**Charlotte-Mecklenburg Planning, Design, & Development**

**SUBJECT:** Administrative Approval for Petition No. 2012-102 Eastway Holdings

**DATE:** September 3, 2020

**SUBJECT:** Site Review Petition: 2012-102 Eastway Holdings

SHEET NUMBER  
 L-110

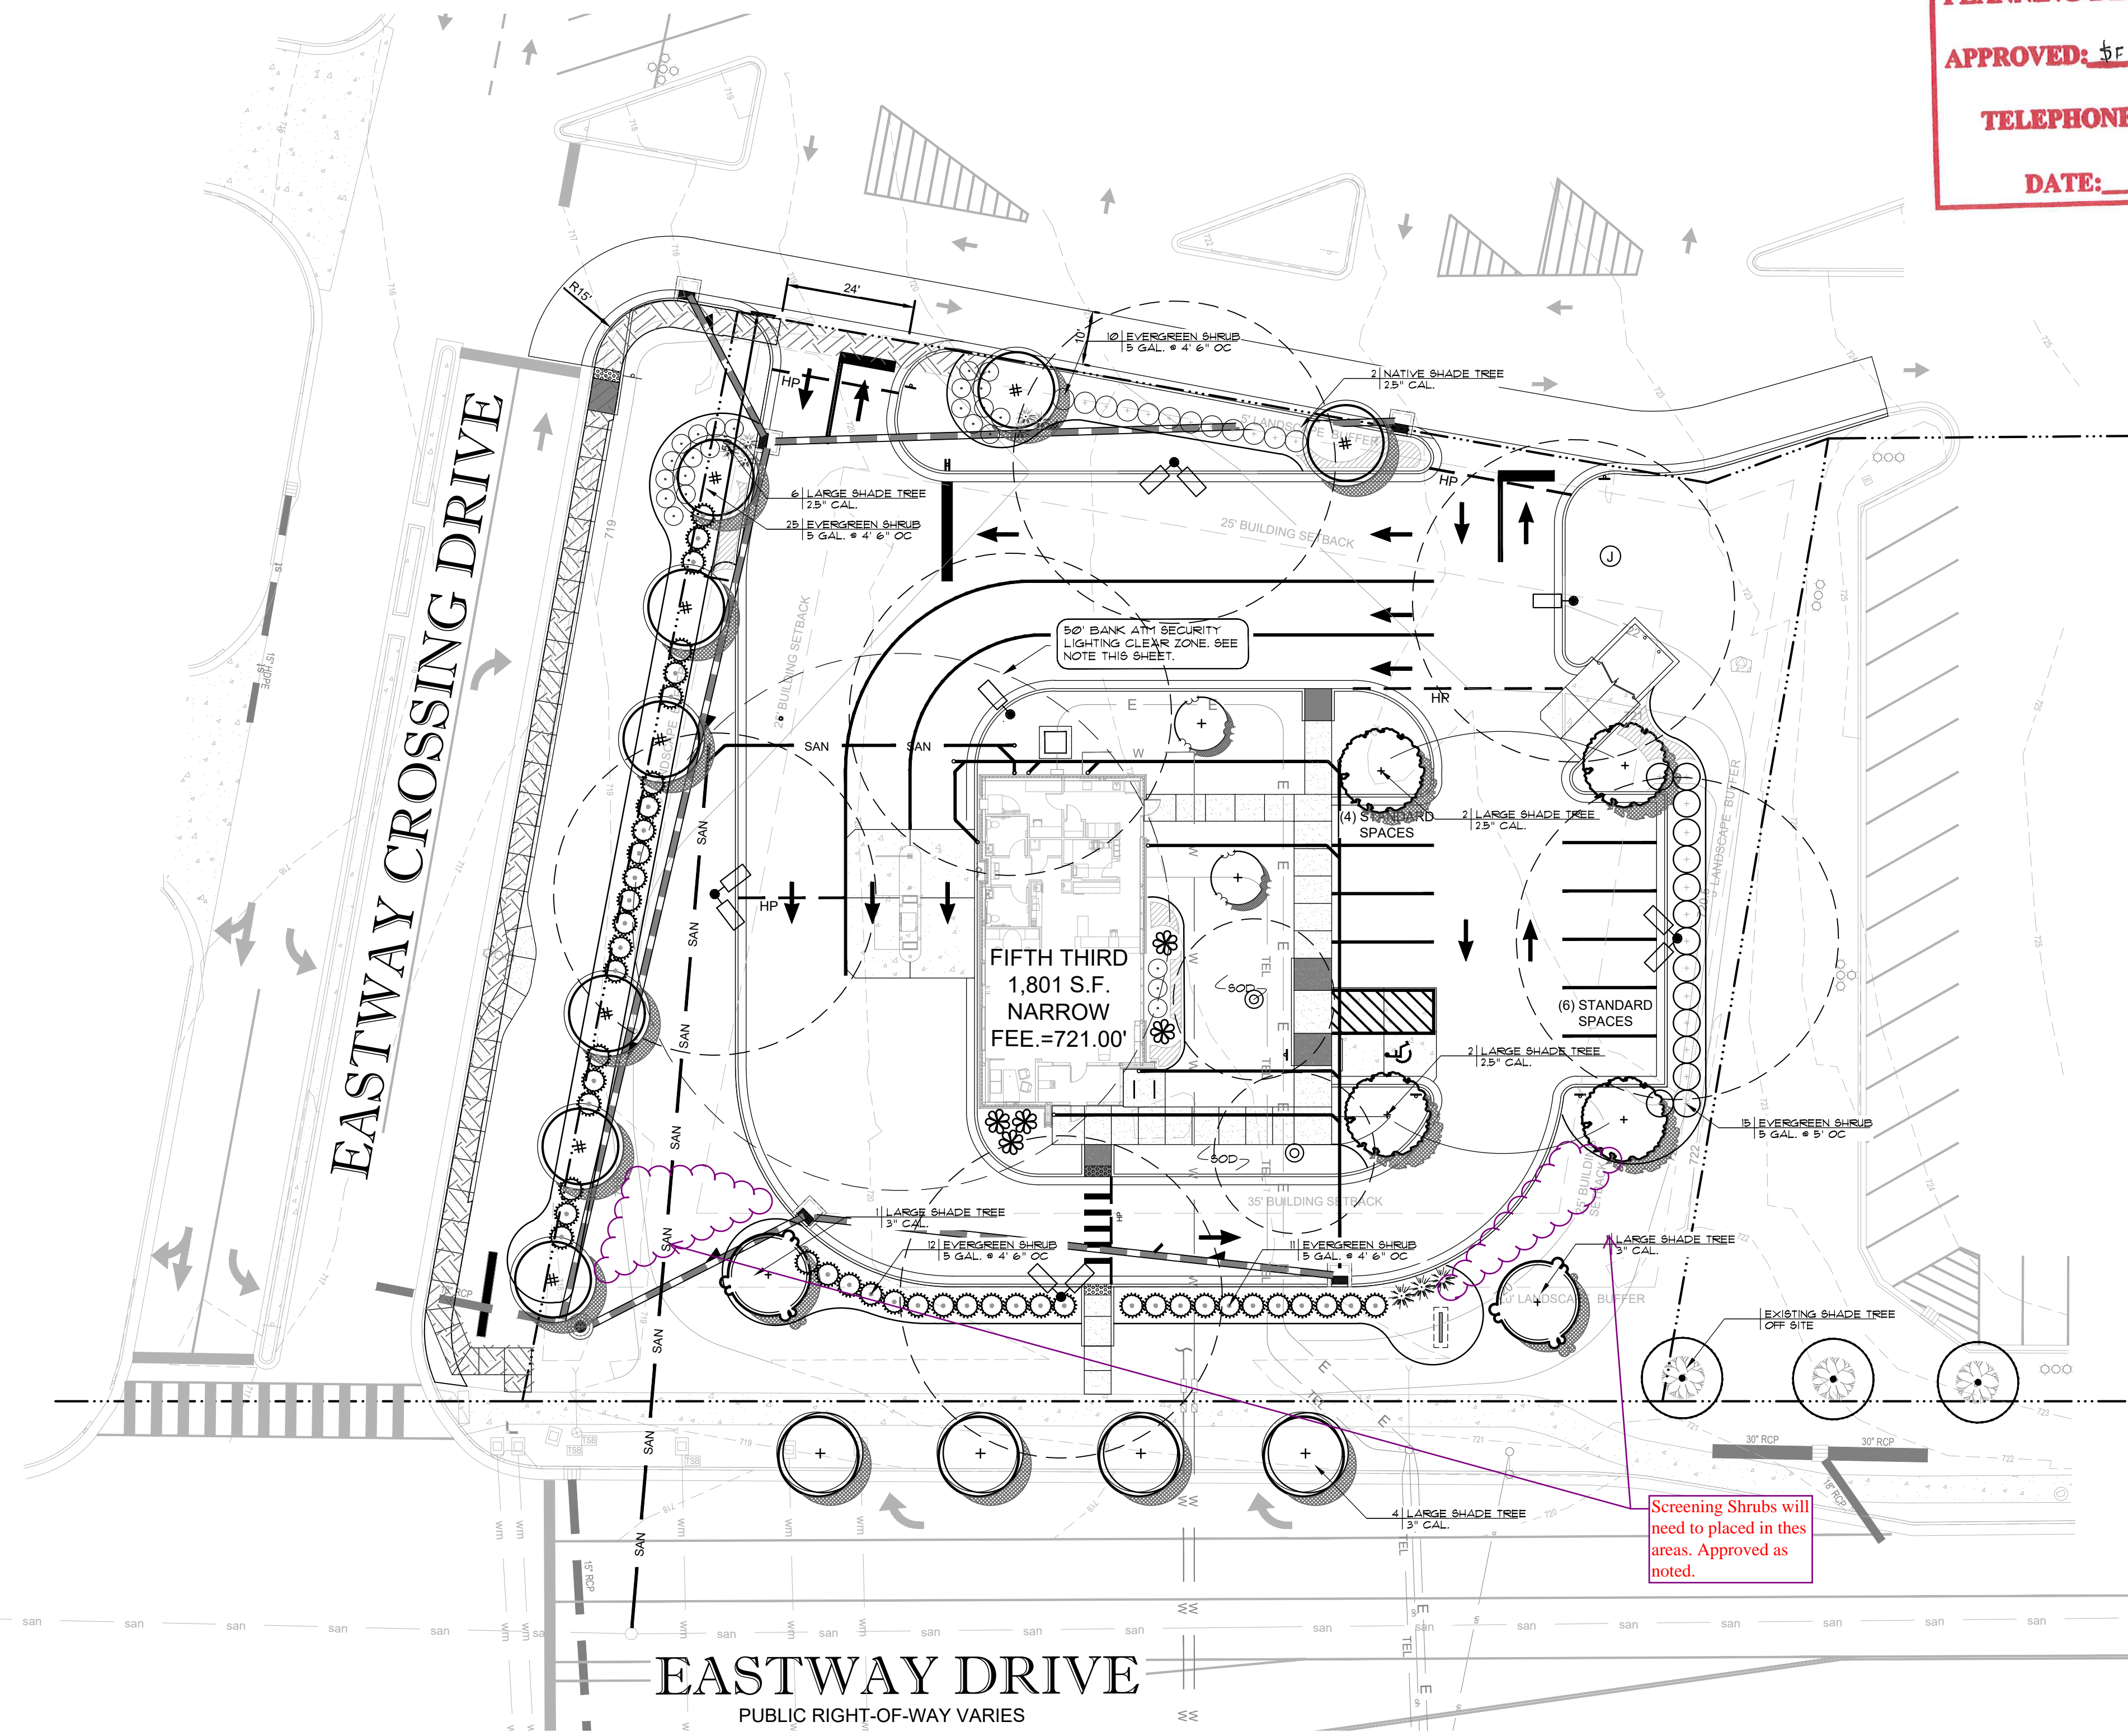
Screening Shrubs will need to be placed in these areas. Approved as noted.
